HARTING Pushing Performance	HARTING Product Change Notification	PCN
--	--	------------

PI00000163-US

Product Range: Han HPR Compact

Title: Han HPR Compact Cover Change

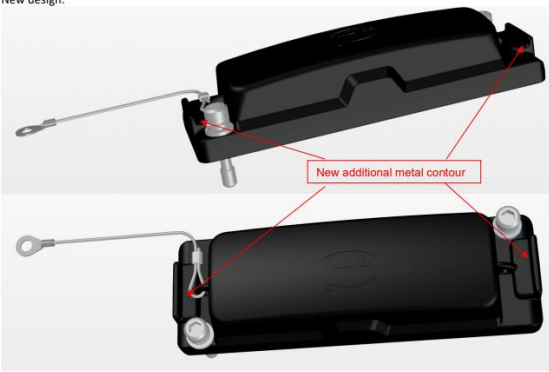
1. Concerned Part Numbers	
09405065411, 09405105411, 09405165411, 09405245411	
2. Description of Changes/News	
Newly incorporated will be an additional metal contour on both sides of the cover. This modification will allow universal use of the covers for screw locking and lever locking housings. Current design:  New design: 	
3. Impact on Product Specification	
The technical characteristics and quality attributes outlined in the datasheet will remain unaffected.	
4. Scheduled Date of Implementation	
01/10/2024	
5. Identification of Change	
New revision level	
6. Datasheet	
For updated specifications and drawings, please check the eCatalogue.
